**Re: Case No. 21-4-EL-BGN**

In the Matter of the Application of Tymochtee Solar, LLC for a Certificate of Environmental Compatibility and Public Need to Construct a Solar-Powered Electric Generation Facility in Wyandot County, Ohio

**Third Supplement to Application – Facility Layout – Updated Figure 3-2**

**Reference:** Inverter Adjustment and Panel Removal

Figure 03-2. Facility Overview with Highlighted Adjustments

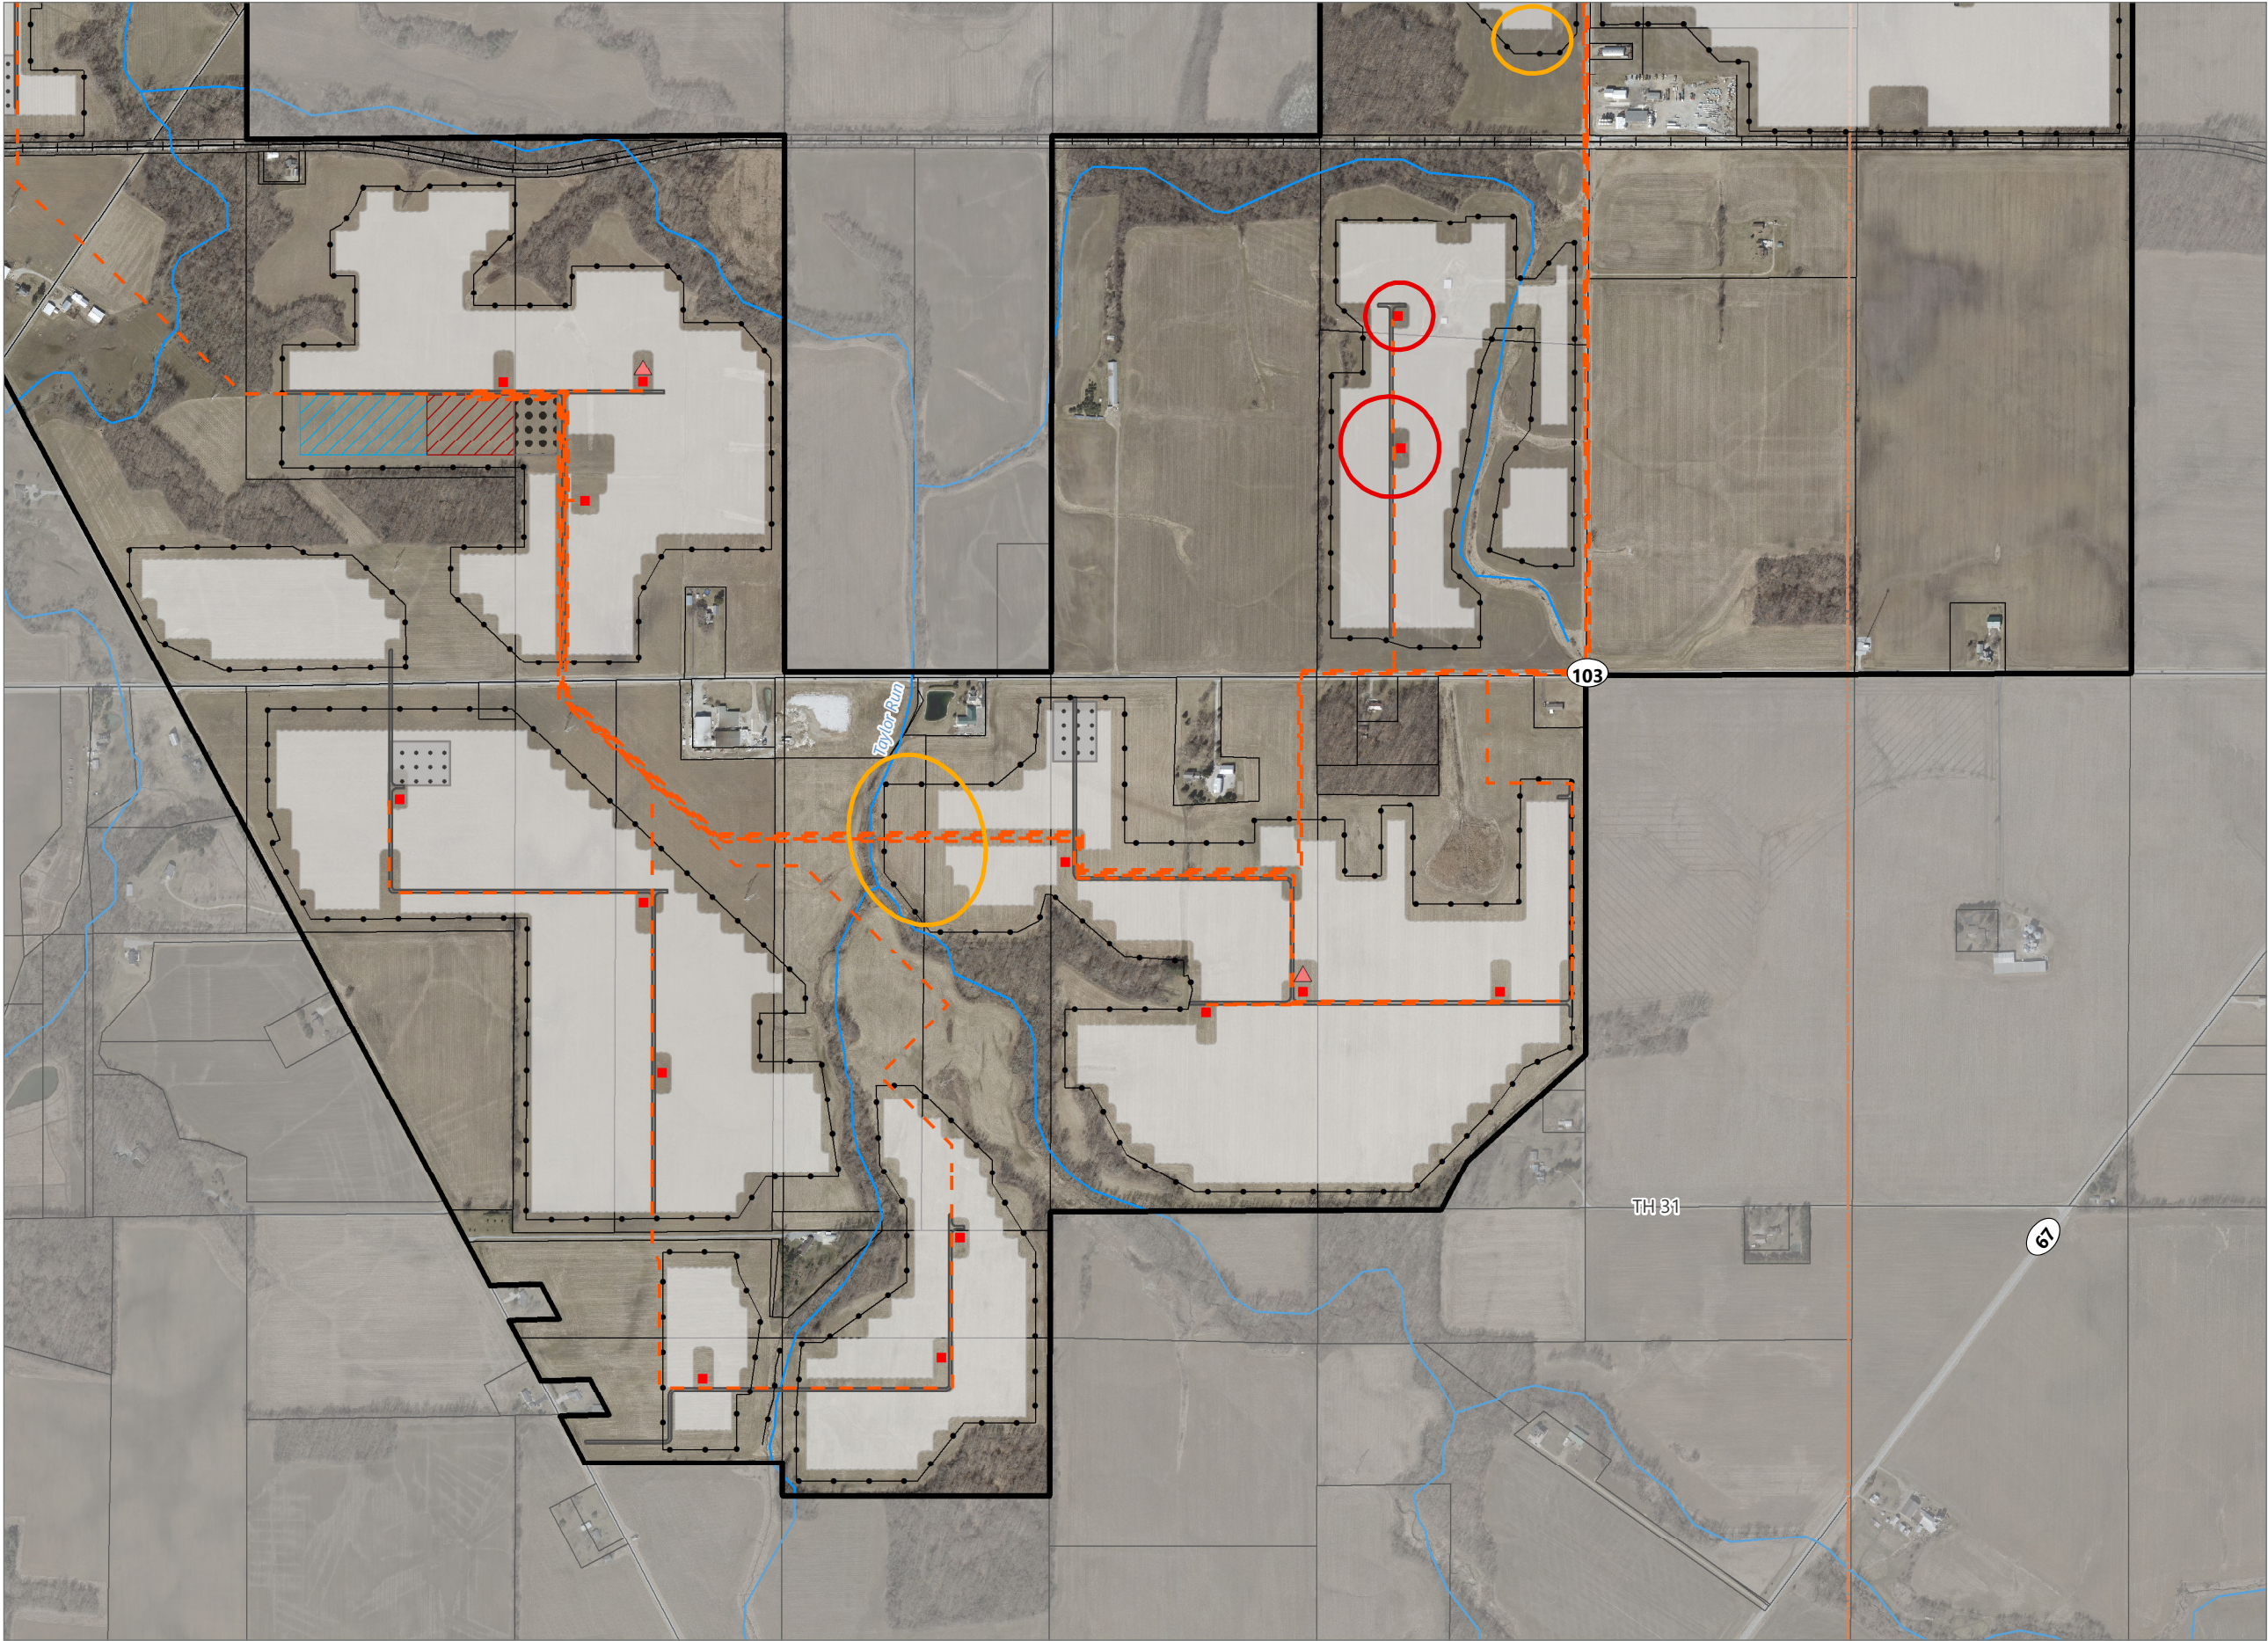
Tymochtee Solar has since reviewed this issue and has been able to make some minor adjustments to its planned facility layout. These adjustments were designed to resolve the potential noise concern while posing no additional adverse environmental impacts. The planned locations of two inverters have been shifted to increase their distance from the facility fenceline. These shifts also necessitated the removal of some planned panel areas for the placement of the inverters. Attached are two sets of Figure 3-2 that reflect these facility layout revisions. The first set of Figure 3-2 titled "Facility Overview with Highlighted Adjustments" shows the locations of these facility layout revisions on sheet 3. The second set of Figure 3-2 titled "Facility Overview" is a clean version of the Figure 3-2 and it supersedes and replaces Figure 3-2 that was filed with the Application on April 29, 2021.

Additionally, to address feedback from Ohio's State Historic Preservation Office, panel arrays were removed at two locations, which are shown on sheets 2 and 3 of the attached Figure 3-2 Facility Overview with Highlighted Adjustments map. These adjustments are also included on the attached Facility Overview clean version of the updated Figure 03-2 map.
